Aliza Fashions Ltd. Aliza Fashion Trousers Ltd.

Chaydana, National University, Gazipur
(23.957721N, 90.378621E)
29th March 2015

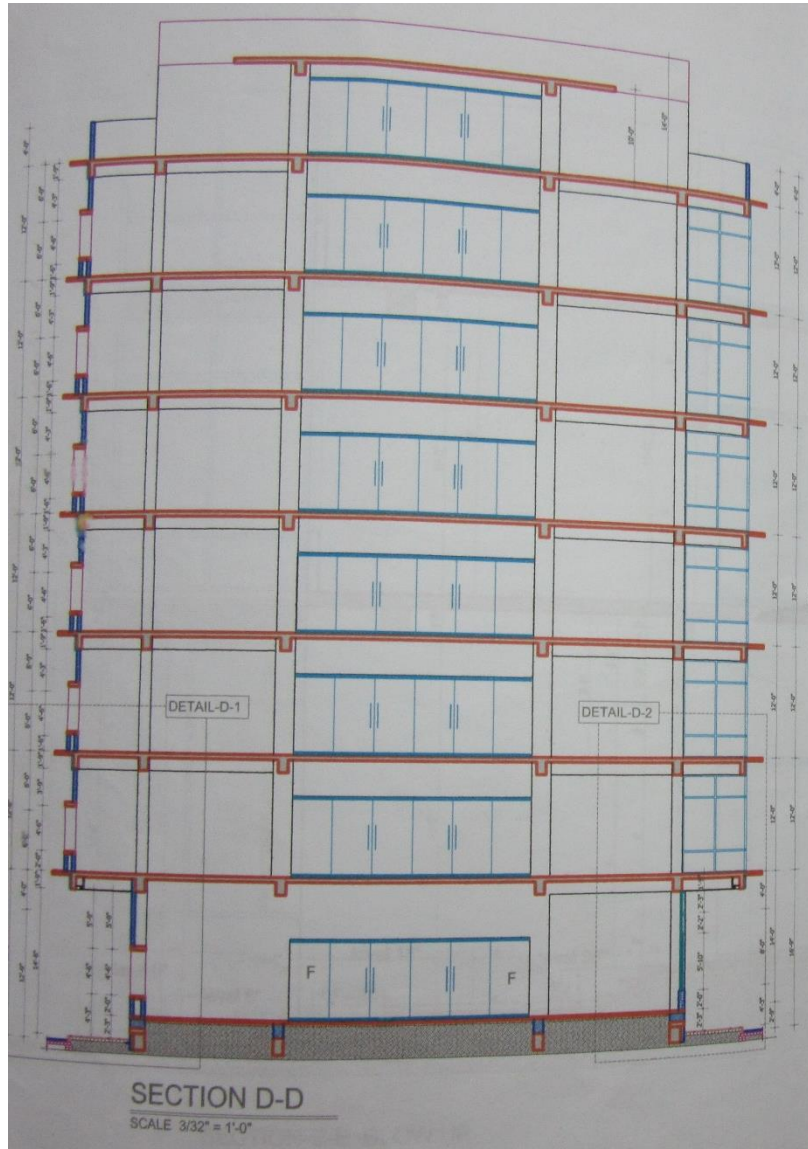
Cantilever slabs to all levels at north and south elevations

Long cantilevers at all floors.

Item No.	Observation	Recommended Action Plan	Recommended Timeline
8	Cantilever slabs to all levels at north and south elevations	As part of the DEA, Building Engineer to carry out a design check of the cantilevers to ensure structural integrity of the slabs and beams.	6-weeks
9	Cantilever slabs to all levels at north and south elevations	Implement any actions arising from design check.	6-months
10	Heavily loaded areas	As part of the DEA, Building Engineer to confirm design loading of slabs and incorporate it into the loading plan for all floor plates.	6-weeks
11	Heavily loaded areas	Produce a loading plan and actively manage the floor loading for all floor plates giving consideration to floor capacity and column capacity.	6-weeks
12	Heavily loaded areas	Continue to implement the loading plan.	6-months
